SAFETY EVALUATION BY THE OFFICE OF NUCLEAR REACTOR REGULATION

RELAXATION REQUEST FROM "ORDER MODIFYING LICENSES

EXAMINATION OF REACTOR PRESSURE VESSEL HEAD PENETRATION NOZZLES

ARKANSAS NUCLEAR ONE, UNIT 1

Figure 1

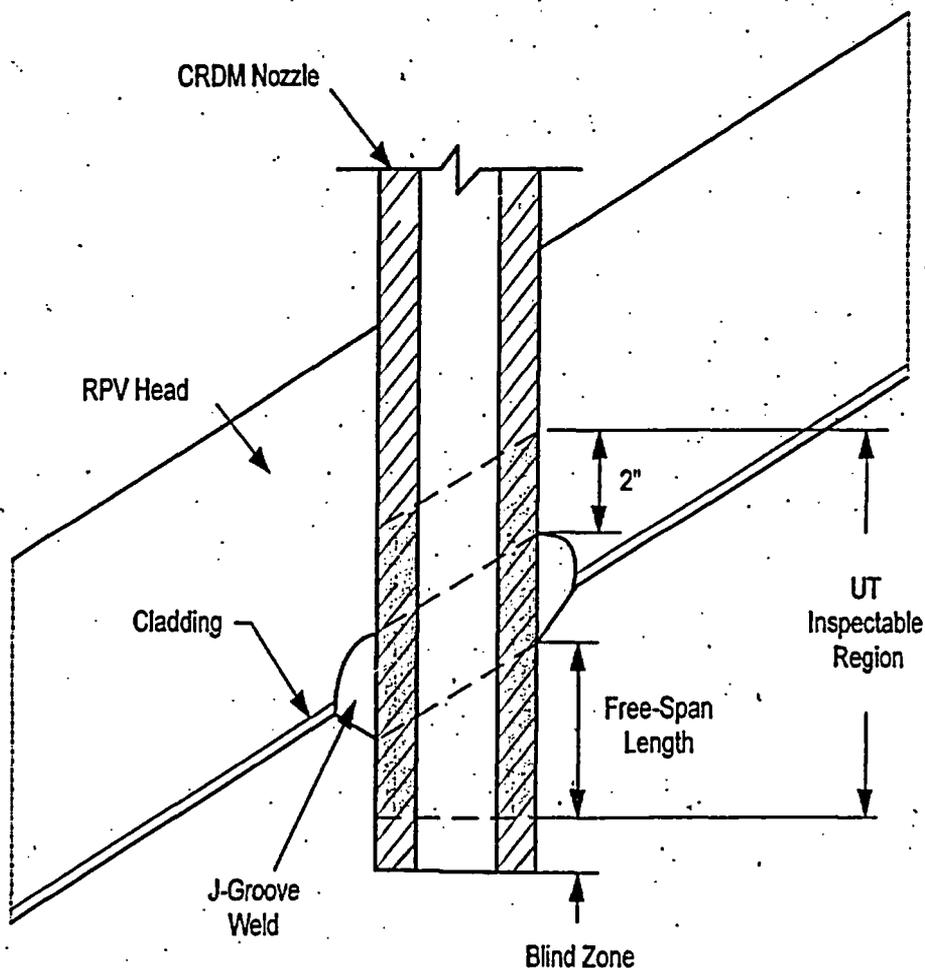
The licensee stated that the ID surface of each RPV head penetration nozzle (i.e., nozzle base material) shall be ultrasonically examined from 2 inches above the J-weld to 0.516 inches above the bottom of the nozzle. This 0.516-inch "blind zone" is due to a limitation resulting from inspection probe design. Entergy will perform UT examination of the ANO-1 RPV head nozzles using the time-of-flight diffraction (TOFD) technique. The TOFD technique utilizes one pair of transducers aimed at each other looking in the axial direction of the penetration nozzle tube. One of the transducers sends sound into the inspection volume while the other receives the reflected and diffracted signals as they interact with the material. The TOFD technique is used to detect and characterize planar-type defects within the full volume of the tube. The UT examination procedures and techniques to be utilized at ANO-1 have been satisfactorily demonstrated under the Electric Power Research Institute (EPRI) Materials Reliability Program (MRP) Inspection Demonstration Program. Also, the licensee will perform an assessment to determine if leakage has occurred into the interference fit zone, as currently specified in Section IV.C.(1)(b)(i) of the Order. The licensee defined the term "blind zone" as the length portion of the RPV nozzle tube that cannot be inspected. The term "free-span" was defined as the bottom of weld minus the blind zone, and this area below the weld is accessible for volumetric examination. The term "available propagation length" was defined as the bottom of weld minus the top of the crack tip, and that is the area available for crack growth. Figure 1 below shows the inspection areas of a CRDM nozzle as defined by the licensee.

The analyses performed in the engineering evaluation are designed to determine the behavior of postulated cracks that could exist in the blind zone. Hence, the crack growth region is from the top of the blind zone to the bottom of the weld (see Figure 1). The engineering evaluation included: design review of the RPV head construction, detailed residual stress analysis, selection of representative nozzle locations, utilization of representative fracture mechanics models, and the application of a suitable crack growth law.

The staff finds that the licensee's proposed alternative examination of the 60 CRDM RPV head penetration nozzles and one radiation calibration instrument nozzle using UT from 2 inches above the J-groove weld down to a point approximately 0.516 inch above the bottom of the nozzle provide reasonable assurance of structural integrity of the RPV head, VHP nozzles, and welds. Further inspection of the 60 CRDM nozzles and one radiation calibration instrument nozzle in accordance with Section IV.C.(1)(b)(i) of Order EA-03-009 would result in hardship without a compensating increase in the level of quality and safety. Therefore, pursuant to Section IV, Paragraph F, of Order EA-03-009, good cause has been shown for relaxation of the Order, and the staff authorizes, for one operating cycle commencing with the startup from the Spring 2004 refueling outage, the proposed alternative inspection for the 60 CRDM head penetration nozzles and one radiation calibration instrument nozzle at ANO-1, subject to the following condition:
